APPENDIX A

IMPROVED RAOC F_Q SURVEILLANCE TS

APPENDIX B

IMPROVED RAOC F_Q SURVEILLANCE TECHNICAL SPECIFICATION BASES

Figure B 3.2.1C-1 (page 1 of 1)
 $K(Z)$ - Normalized $F_0(Z)$ as a Function of Core Height

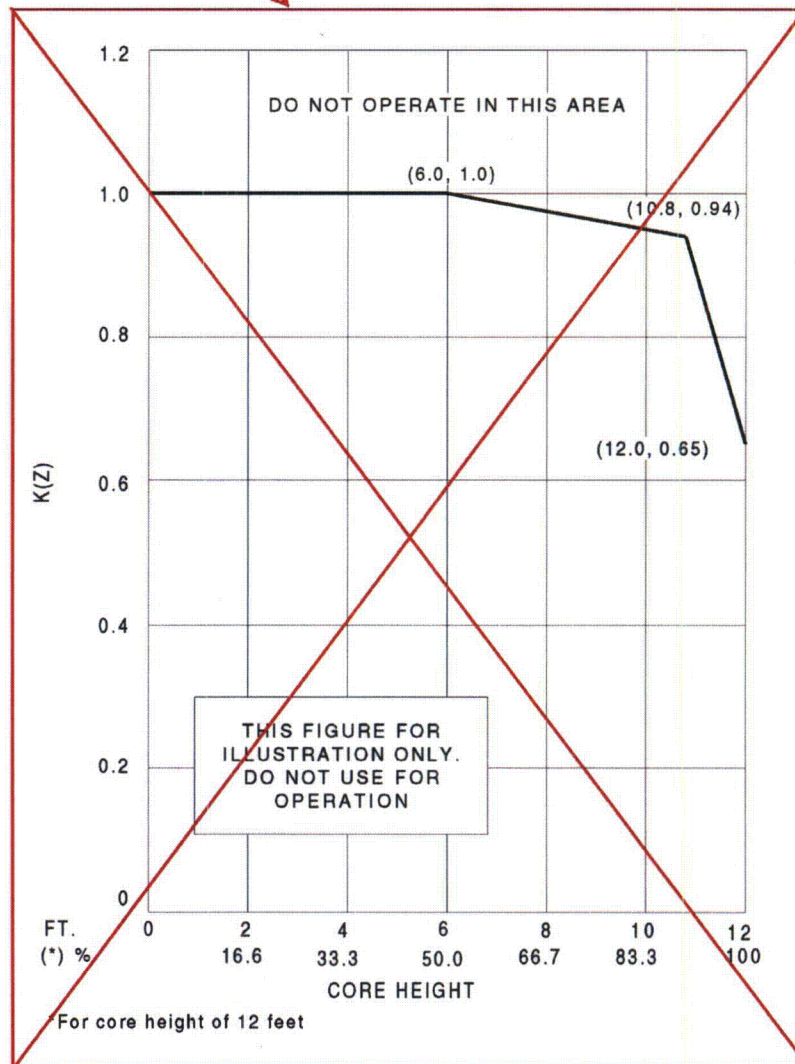
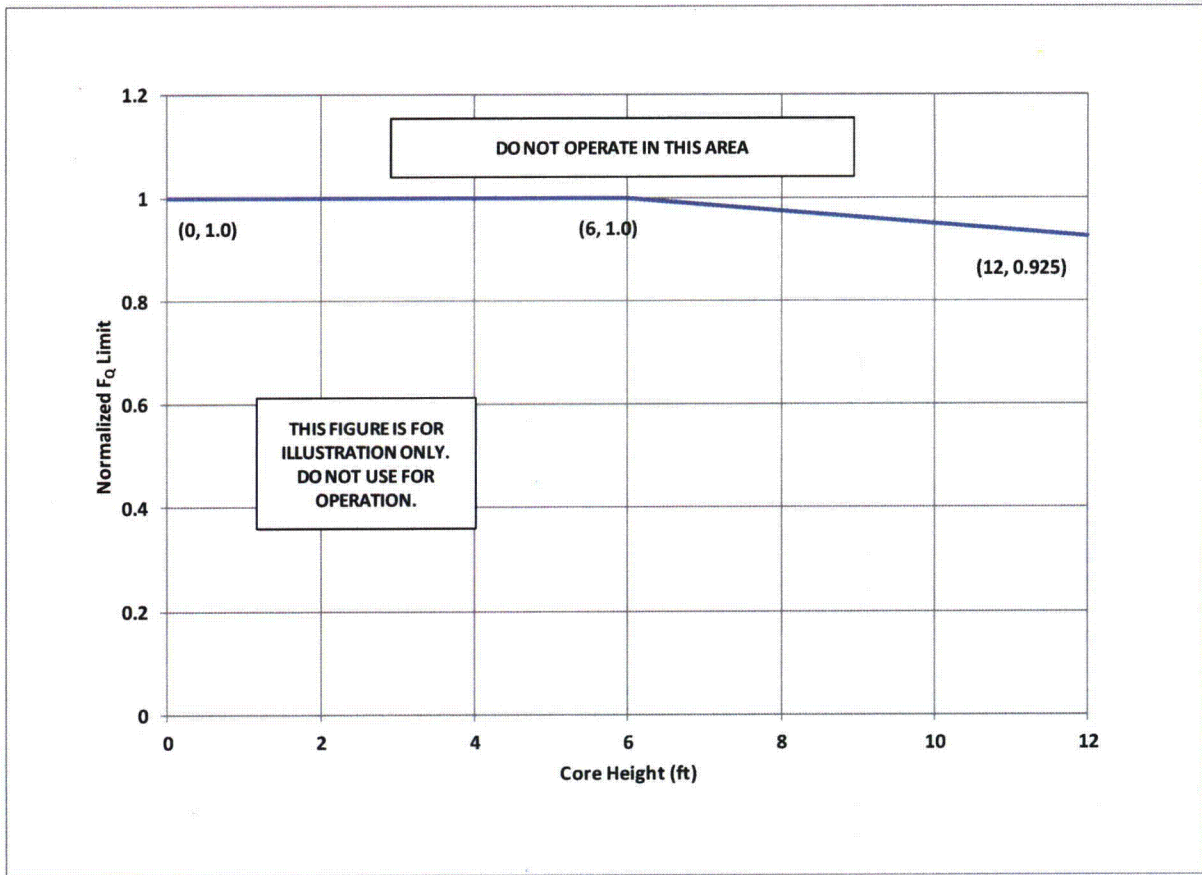
Insert new Figure
(Next Page)

For this facility, the actual values of CFQ and $K(Z)$ are given in the COLR; however, CFQ is normally a number on the order of [2.32], and $K(Z)$ is a function that looks like the one provided in Figure B 3.2.1C-1.
